UNITED STATES PATENT AND TRADEMARK OFFICE

APPLICATION NO.	FILING DATE	FIRST NAMED INVENTOR	ATTORNEY DOCKET NO.	CONFIRMATION NO.
10/524,631	03/29/2007	Shigemitsu Kikuchi	KUD-003	1444

Office Action Summary	Application No. 10/524,631	Applicant(s) KIKUCHI ET AL.	
	Examiner JONATHAN KOAGEL	Art Unit 3744

DETAILED ACTION

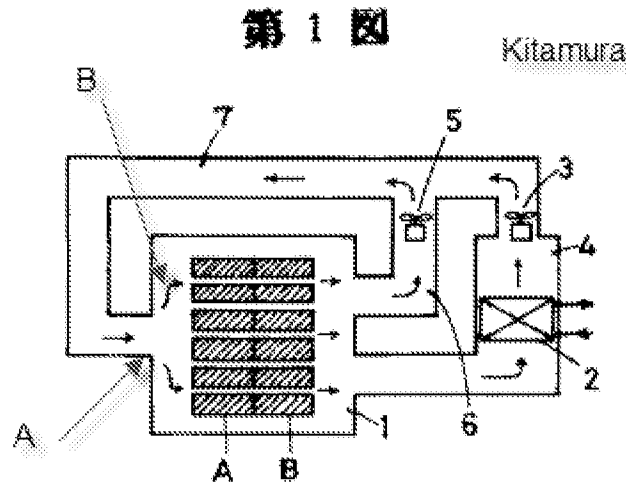
Regarding claim 1, Kitamura teaches in fig. 1, a cooling warehouse 1 comprising a first cooled air introducing pipe 4 introducing a first cooled air cooled by an air refrigerant type cooling apparatus 2, a second cooled air introducing pipe 6 taking in second cooled air in said cooling warehouse 1, an air introducing port A (See annotated Figure below) introducing a mixed air in which said first cooled air (from pipe 4) and said second cooled air (from pipe 6) are mixed into said cooling warehouse 1.

Regarding claim 2, Kitamura further teaches in fig. 1, wherein said air introducing port A is opened on a duct B (See annotated Figure below) set in said cooling warehouse 1.

Regarding claim 3, Kitamura further teaches in fig. 1, wherein said second cooled air introducing pipe 6 is set to an outside of said cooling warehouse 1 and one end of

said second cooled air introducing pipe 6 is opened on a wall face of said cooling warehouse 1.

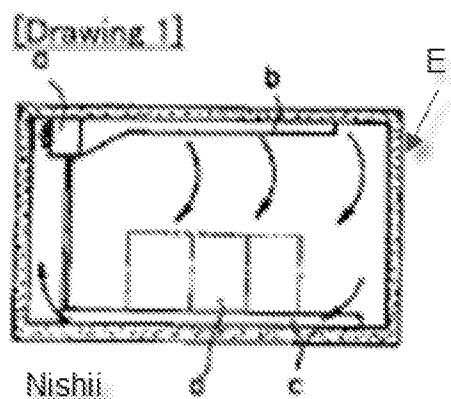
Regarding claim 4, Kitamura teaches the invention as disclosed above but fails to explicitly teach where said second cooled air introducing pipe is set inside said cooling warehouse.

However, Nishii teaches in fig. 1, wherein said second cooled air introducing pipe c is set inside said cooling warehouse E (See annotated Figure below paragraphs 1 and 2).

It would have been obvious to one of ordinary skill in the art at the time of invention to modify Kitamura with the teachings of Nishii to include a second cooled air introducing pipe inside the cooling warehouse in order to prevent heat transfer from occurring between the second cooling pipe and an external environment. Heat transfer with an external environment will raise the temperature within the second cooled air introducing pipe and will force a higher load upon the air refrigerant cooling apparatus. Therefore by locating the second cooled air introducing pipe inside of the cooling warehouse, the cooling system will be more efficient and result in a lower operating cost.

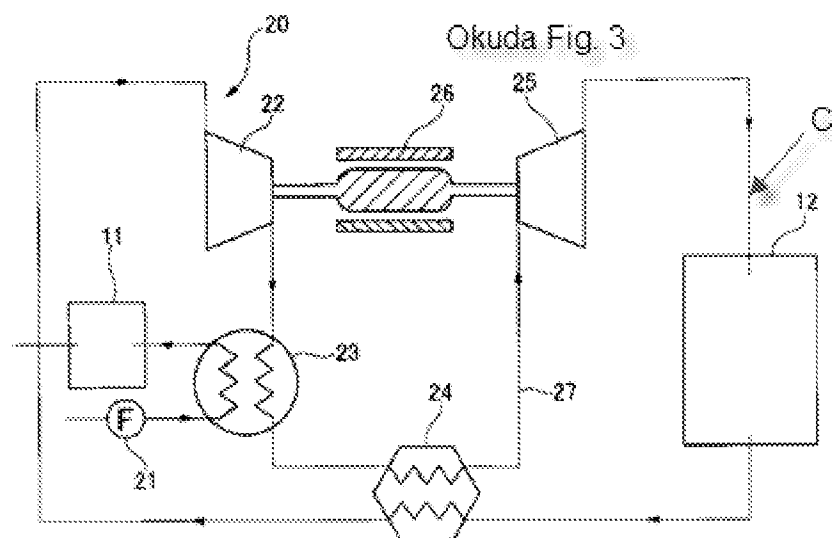
Regarding claim 5, Okuda teaches in fig. 3, an air refrigerant type cooling system comprising, an air refrigerant type cooling apparatus 20 and a cooling warehouse 12, wherein said air refrigerant type cooling apparatus includes a compressor 22 compressing a refrigerant air coming out of said cooling warehouse 12, a heat exchanger 23 cooling said refrigerant air coming out of said compressor 22, an expansion turbine 25 expanding said refrigerant air coming out of said heat exchanger 23 and supplying said refrigerant air to said cooling warehouse 12, and said cooling warehouse includes a first cooled air introducing pipe C (See annotated Figure below) introducing said refrigerant air coming out of said expansion turbine 25 (pg.3 paragraph 11-pg. 4 paragraph 14). Okuda fails to explicitly teach a second cooled air introducing pipe or an air introducing port.

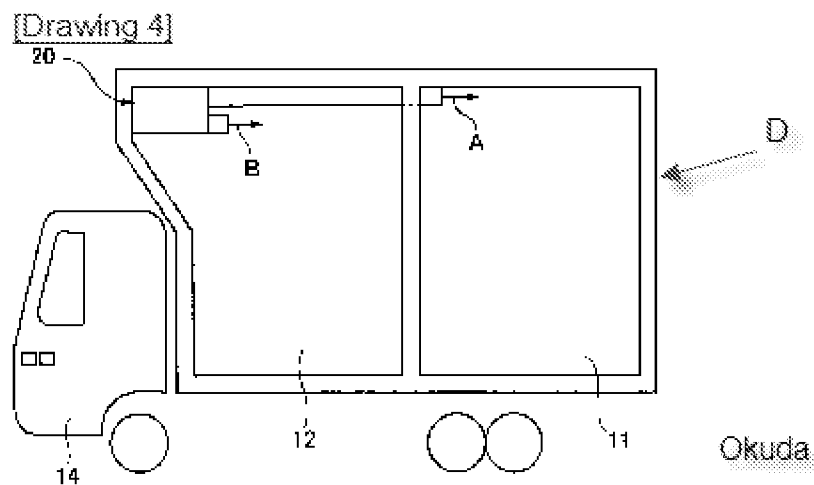
Regarding claim 6, Okuda and Kitamura teach all the limitations that can be seen in claim 5 above. Okuda further teaches in fig. 4, a carriage D (See annotated Figure above) mounting said air refrigerant type cooling apparatus 20 and said cooling warehouse 12.
